Meeting Agenda

Historic Zoning Commission

Monday, February 13, 2023

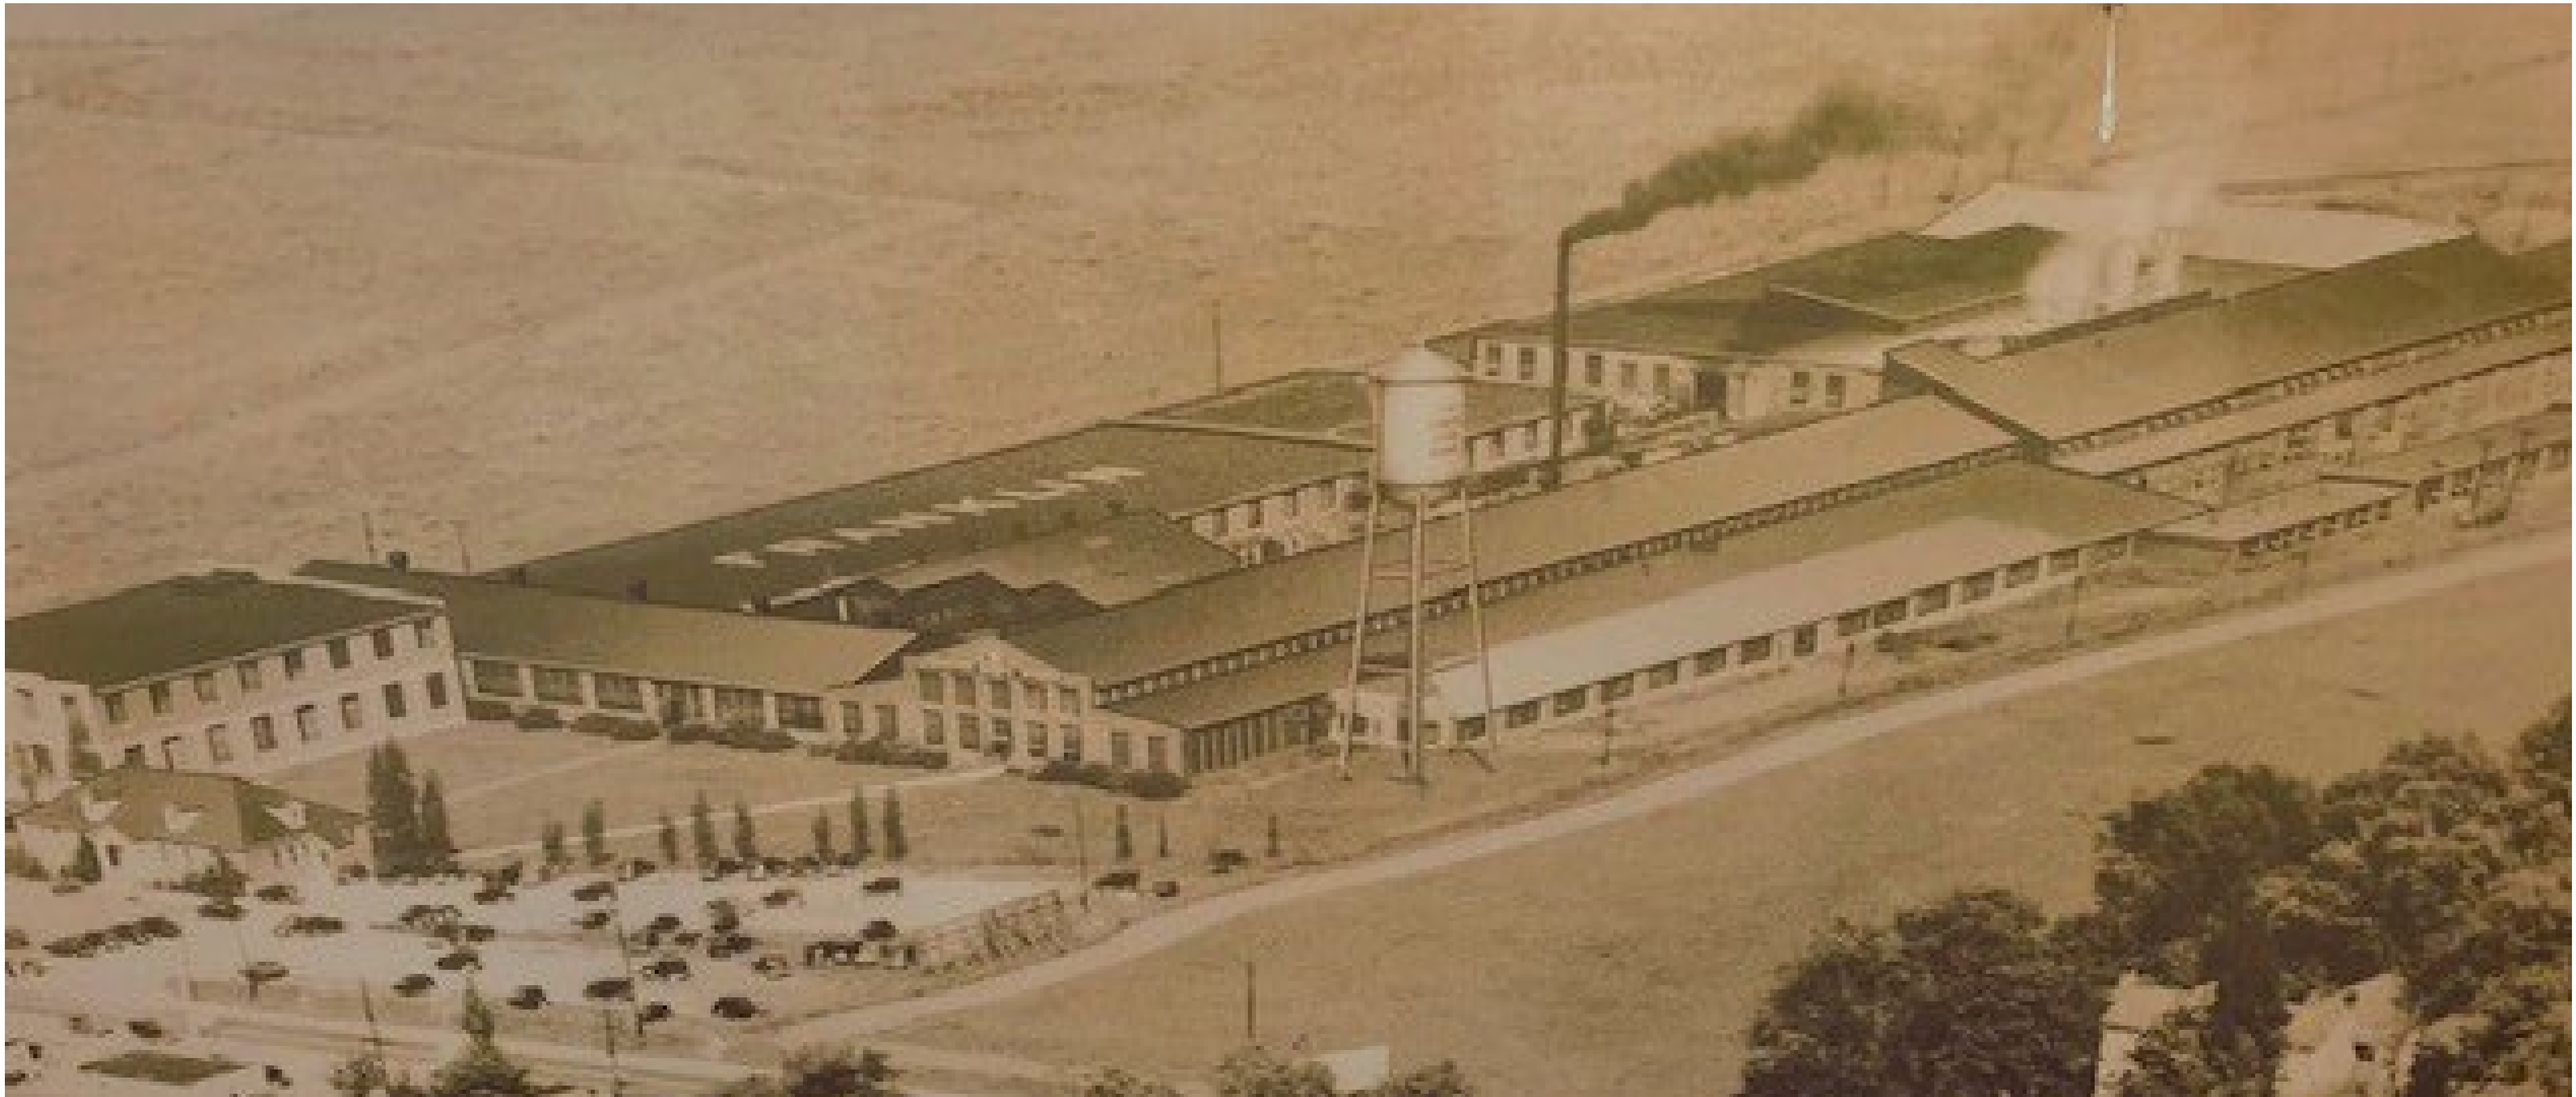
The proposal includes the construction of a brick enclosure to screen trash receptacles and compactors fronting Liberty Pike and a location located near the water tower. One of the locations, near the intersection of Liberty Pike and Franklin Road, will remain as approved, while the location to the right will change from being parallel to Liberty Pike to being perpendicular to the road. Additionally, a third location for trash compactors is being proposed behind an existing retaining wall, near the water tower. As noted on the site plan, the new location for one of the existing refuse areas is noted in red, while the new location by the water tower and the existing refuse areas are in blue.

The proposed screening near the street is to measure 31'-8" in length, 11'8" in width, and 8" in height and consist of masonry walls with a stained cedar gate to access the trash receptacles/compactors.

The Guidelines are not intended to be a comprehensive document that covers all zoning requests, such as the placement of refuse areas, but the Guidelines do note that site and setting alterations should not be undertaken in locations that are visible from the public view and distract from or overwhelm the context of historic districts. The Guidelines also note that fences and walls should measure no more than 3' in front yards, as principal buildings and front yards are more visible from public view sheds.

While the proposal for placement along Liberty Pike is not consistent with the Guidelines, a position parallel to the street is currently approved, and relocation of the red enclosure to be perpendicular to the street minimizes its impact on the pedestrian view sheds. As such, the proposal is supported.

1. The application must meet all the requirements of the City of Franklin prior to the issuance of a building permit.
2. Any additional changes to the approved plans must be returned to the Preservation Planner or the Historic Zoning Commission for review and approval.

1 SITE PLAN
1/8" = 1'-0"

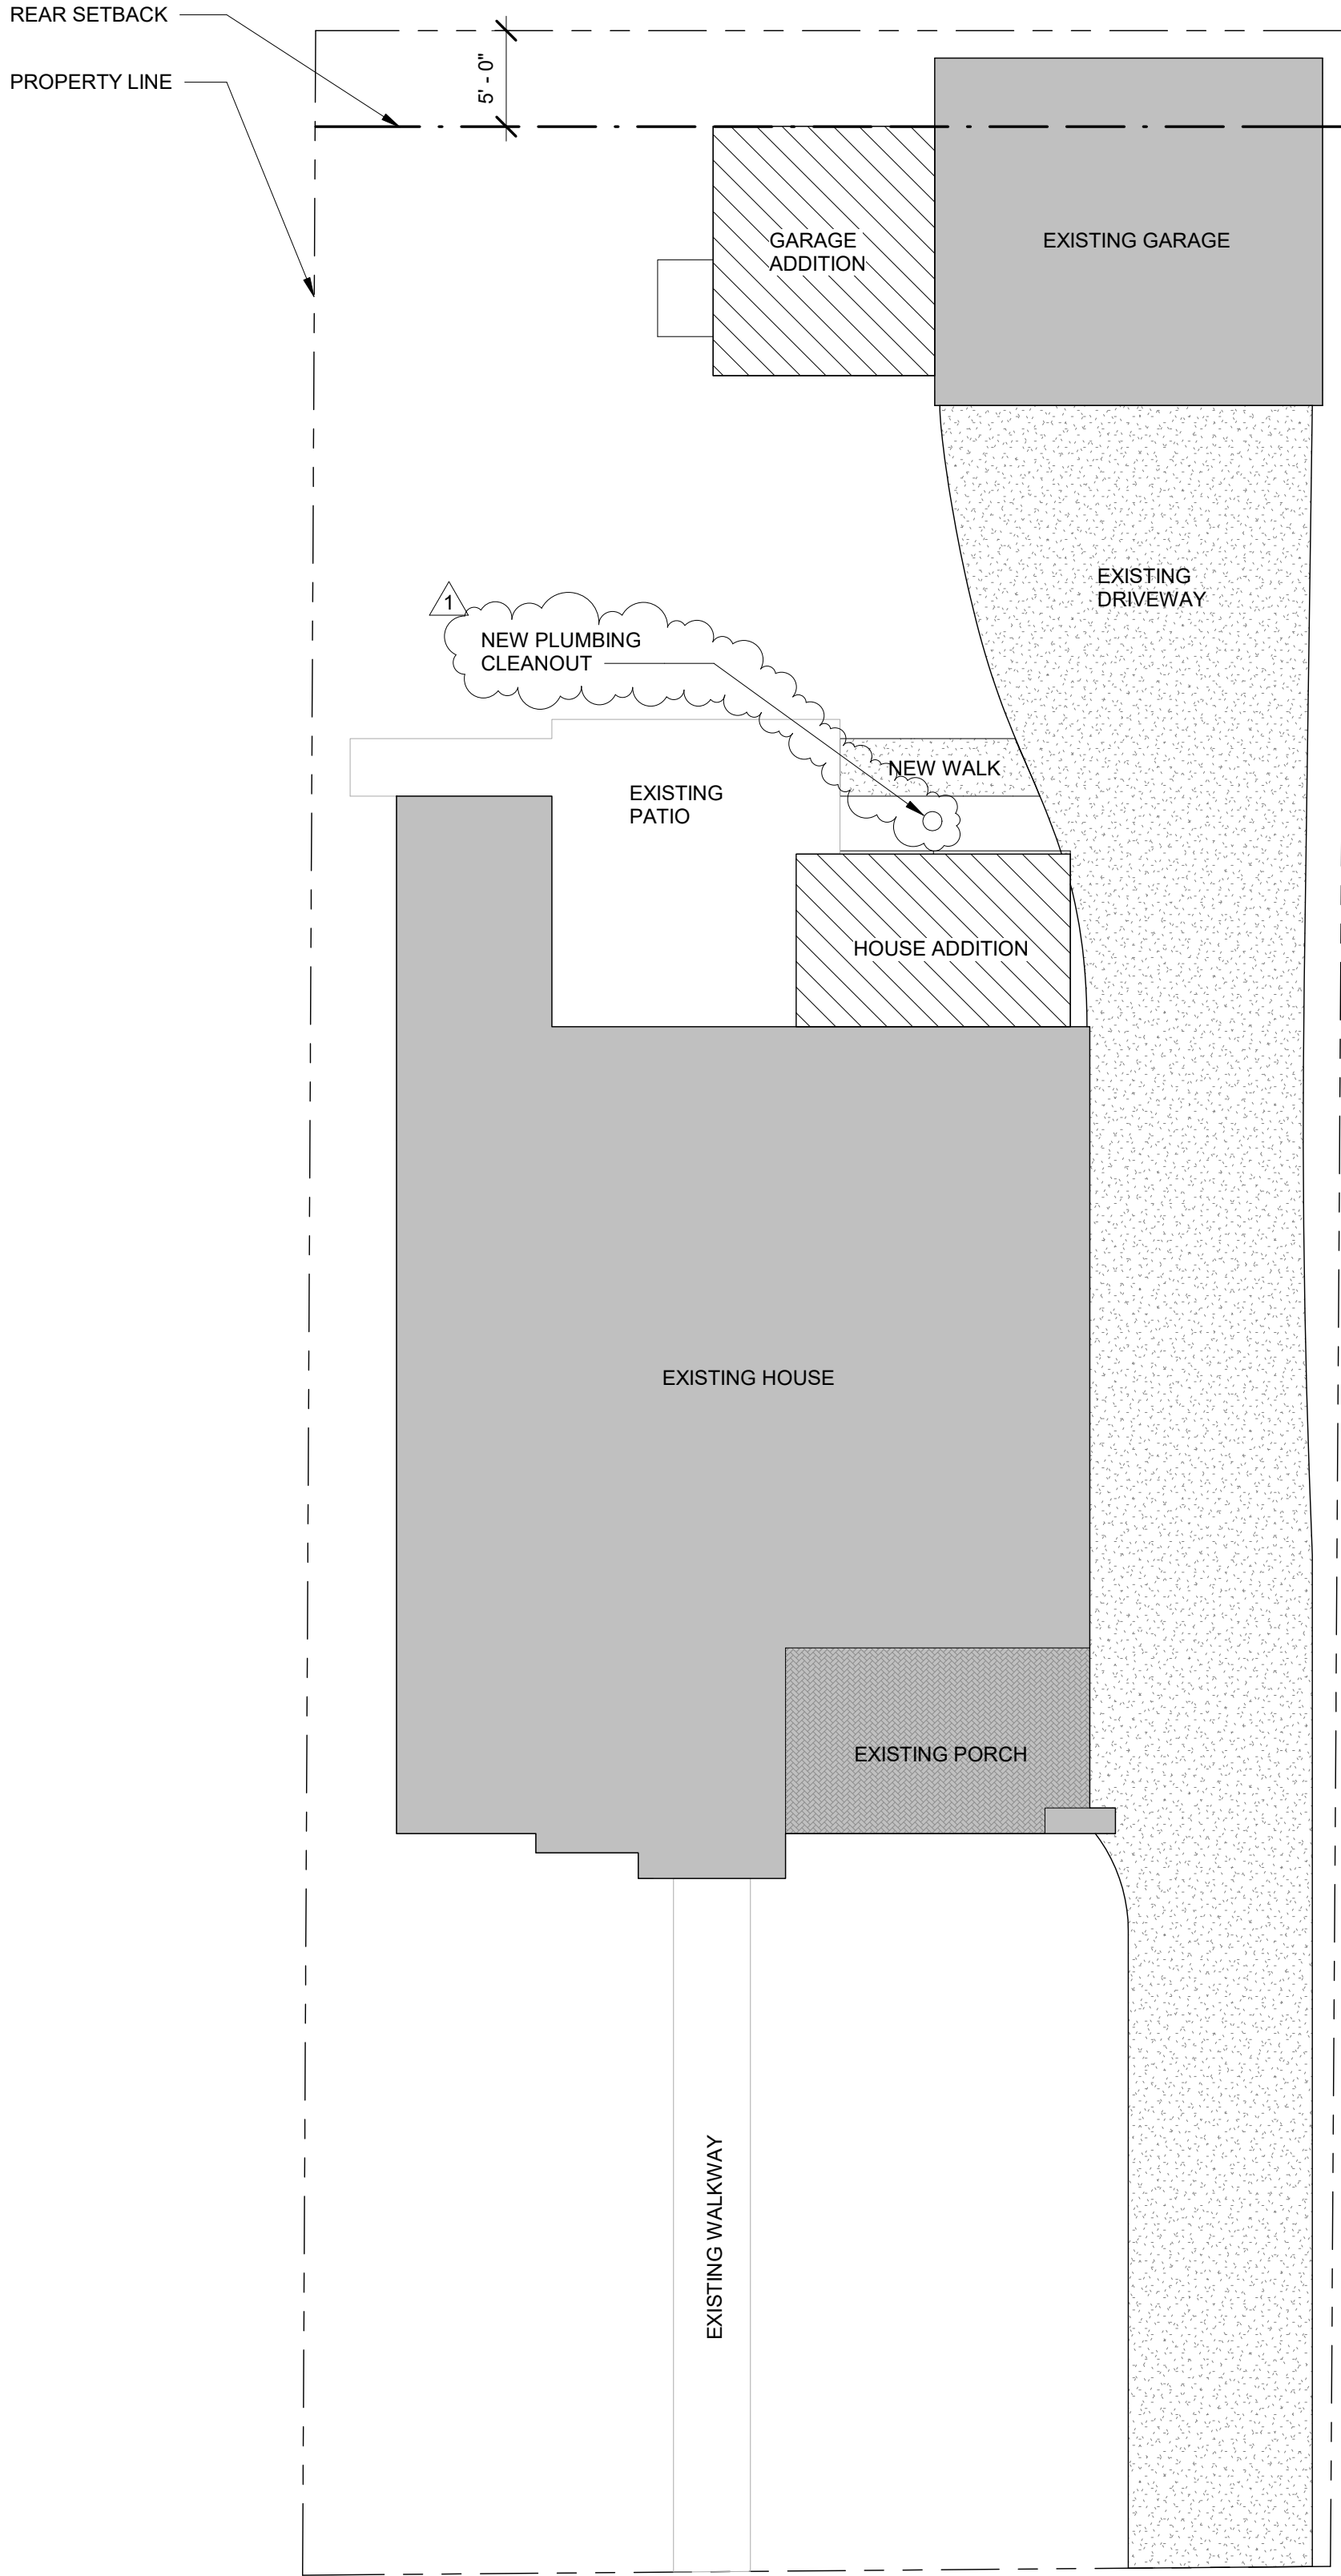
1. On the site plan sheet SP101, identify the location of the curb on the drawing. As discussed previously, the minimum setback for any gate is to be 30 ft from the edge of the travel lane, which is the streetside edge of the on-street parking. On-street parking spaces are to be 8 ft in width as measured from the face-of-curb. It appears the gate is set back appropriately, but without the curb location or dimensions for the on-street parking spaces shown, staff cannot verify.

2. Upon inspection, if the ramp does not screen the HVAC sufficiently from off-site views, additional screening may be required.
3. Applicant shall be aware that no variance or waiver of any requirement of the Zoning Ordinance may be granted through the approval of the Certificate of Appropriateness or associated site plan. The note below which was included on the site plan is not being approved or upheld with the Certificate of Appropriateness, and no variance or legal opinion regarding the note is being rendered by staff's review of the site plan.
